**Purpose of Report:** *New Unit Final Building Survey & Defects Report*  
**Date of Inspection:** 29.3.2006  
**Property Description:** **3 Bed Split Level Penthouse**  
**Address of Property:** **Unit Northcliff St Milsons Point**  
**Building Consultant:** Mr. Dominic Ogburn AMAIB Lic No BC 359  
*e-mail: [info@accesspropertyservices.com.au](mailto:info@accesspropertyservices.com.au)*  
Office (02) 9798 5000 Fax (02) 9225 9656 Mobile 0418 865-663

On behalf of the client **XYZ** I undertook a building survey of the subject **unit NoZ** over one third of a day on **29/3/06**.

*Photo No 64*

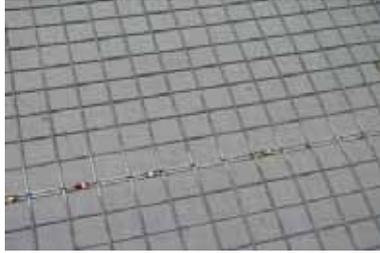
**Color bond metal deck roof;** minor frass related surface rusting evident on upper section of roof over lightwell. *Refer Photo No64* showing significant **surface rusting** has commenced in many of the partially galvanized safety mesh covers, over the A/C plant areas and which require **rust paint rectification**.
